E C O L O G I C A L R E V I E W

South Grand Chenier Hydrologic Restoration

State No. ME-20

November 3, 2009

Figure 1. The South Grand Chenier Hydrologic Restoration (ME-20) project area and features.

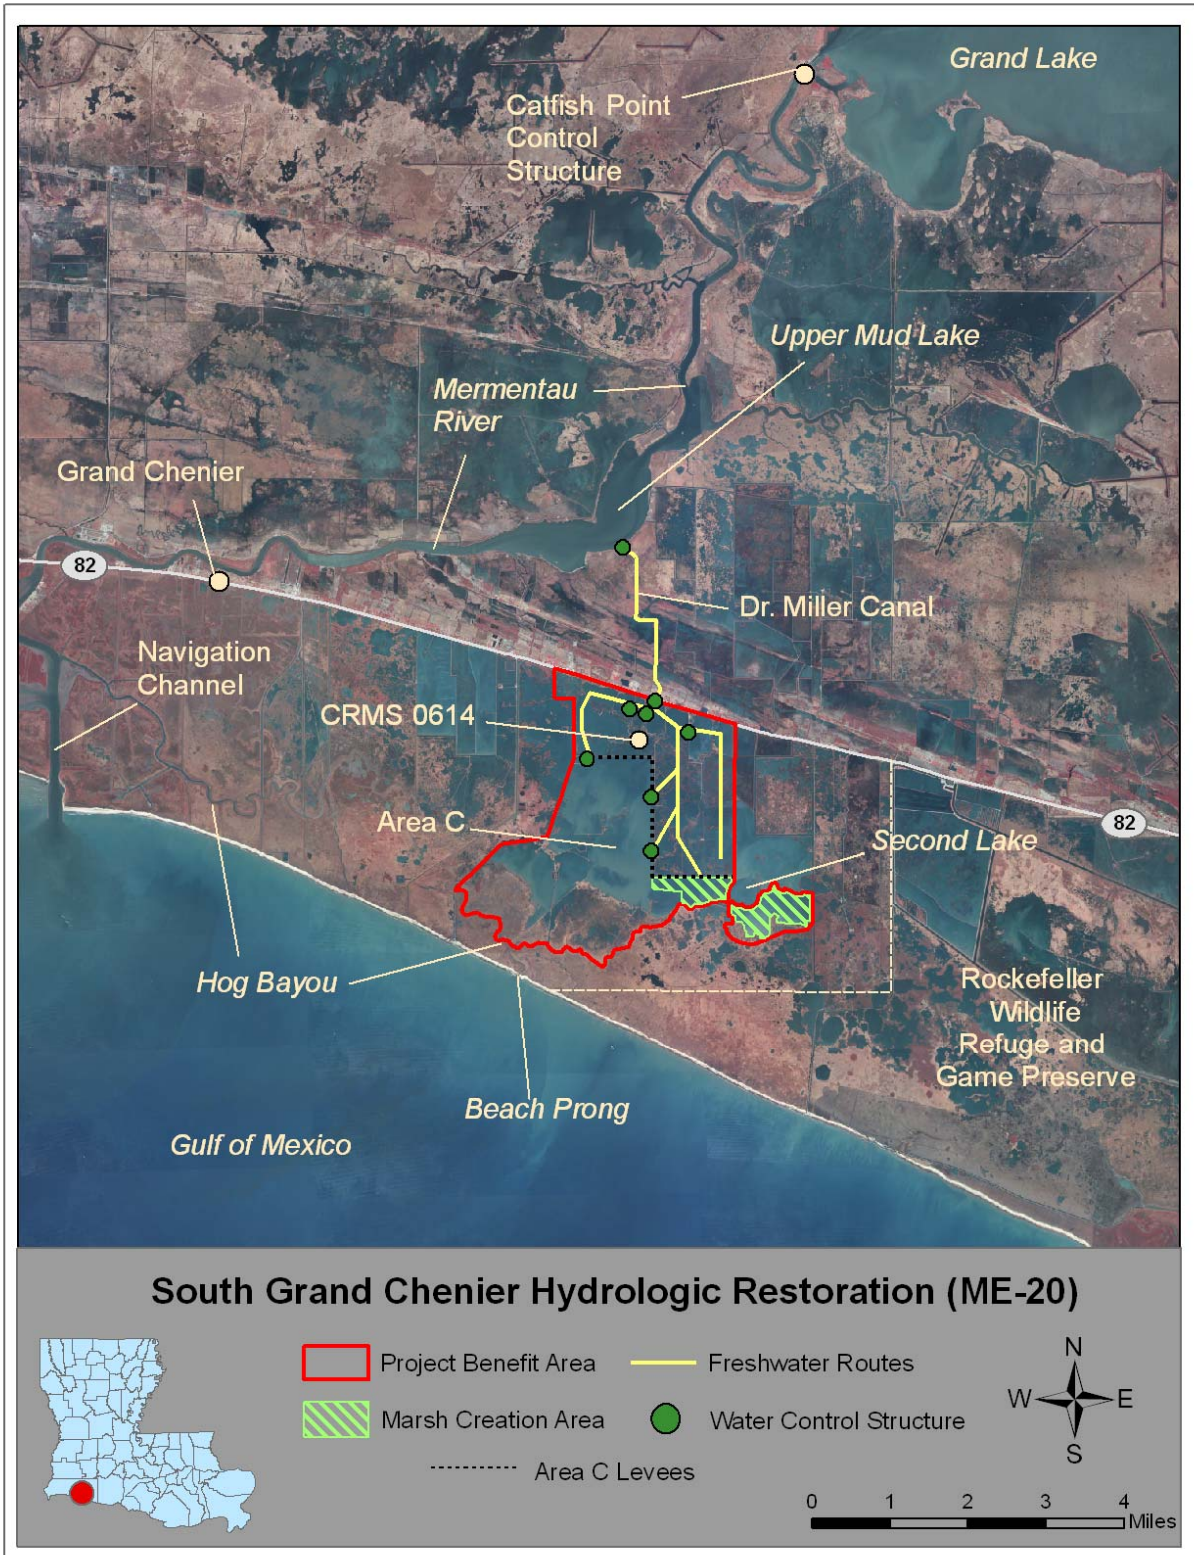
The proper development and long-term sustainability of the created marsh is also dependent on maintaining natural hydrologic exchange with adjacent water bodies. As previously discussed, artificial barriers such as levees, spoil banks, and dikes prevent the influx of vital sediment and nutrients (Boumans and Day 1994, Bryant and Chabreck 1998). These barriers would also block the influx of plant propagules for colonization of the newly created marsh. The containment dikes constructed for the ME-20 project will be degraded to marsh elevation one year after construction, and they should continue to settle along with the marsh platforms. In addition, trenasses will be constructed in the marsh platforms to further facilitate hydrologic exchange to the inner parts of the created marsh. Future maintenance, though, may be necessary to maintain the exchange if the dikes do not settle as anticipated or if the trenasses become plugged by sediment deposition.

- The project's monitoring and operational plan should be coordinated with the existing management plans in the area, and all water control structures should be operated to maximize the benefits of the freshwater introduction.
- Maintenance events should be conducted to further degrade containment dikes and/or reopen trenasses, if necessary, to maintain hydrologic exchange to the created marshes.

Figure 2. Salinity and water level data from CRMS 0614 in the ME-20 project area. The red line depicts the elevation of marsh (+1.2 feet NAVD 88) surveyed in the project area.

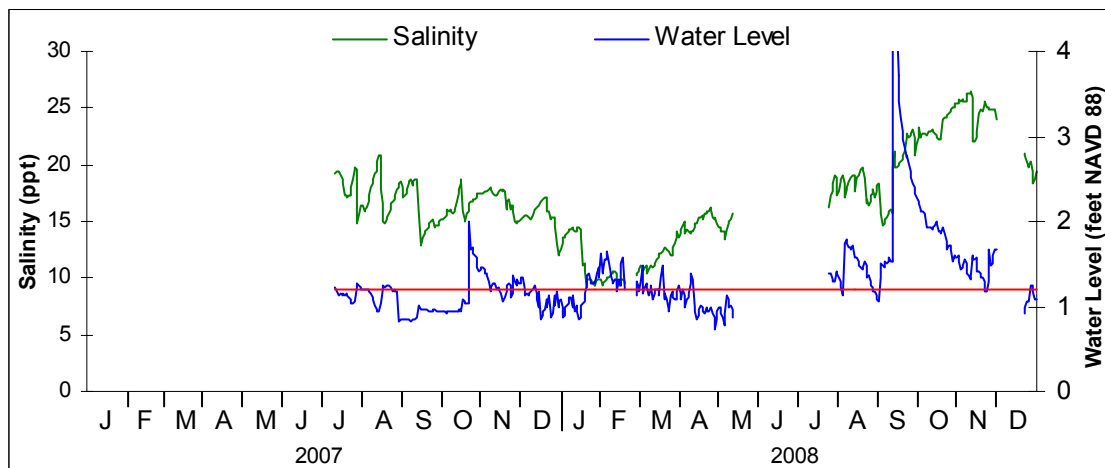
Marshes in the project area are dominated by *Distichlis spicata* and *Spartina patens*, two species that have low flooding tolerance and are more productive in irregularly-inundated, higher elevation habitats (Webb et al. 1995). Consequently, increases to water levels caused by the ME-20 project may be detrimental to local plant productivity. The hydrodynamic model developed by Fenstermaker (2005) found that water levels increased 0.2 feet when the diversion was operating. Fenstermaker (2005) also performed an analysis to determine how the water level increase would affect marsh inundation rates; however, the analysis used a marsh surface elevation of +1.5 feet NAVD 88, which is at the upper limit of marsh elevations in the area and

thus would be least inundated. Therefore, another analysis was performed based on the more conservative +1.2 feet elevation surveyed recently (NRCS and USFWS 2009). Using this elevation and the water level data shown in Figure 2 (data after August 2008 were excluded because of the impacts from Hurricane Ike), the baseline marsh inundation rate was estimated to be a suitable 25% with relatively short-duration flooding events occurring between November and April. With a water level increase of 0.2 feet, the marshes would have been inundated 60% of the time, primarily as a result of flooding events lasting 55 and 80 days. This amount of flooding would significantly decrease growth and productivity, and possibly cause mortality (Webb et al. 1995, Lessmann et al. 1997). Consequently, water levels in the project area should be monitored and the diversion regulated so as to prevent long-duration flooding events.
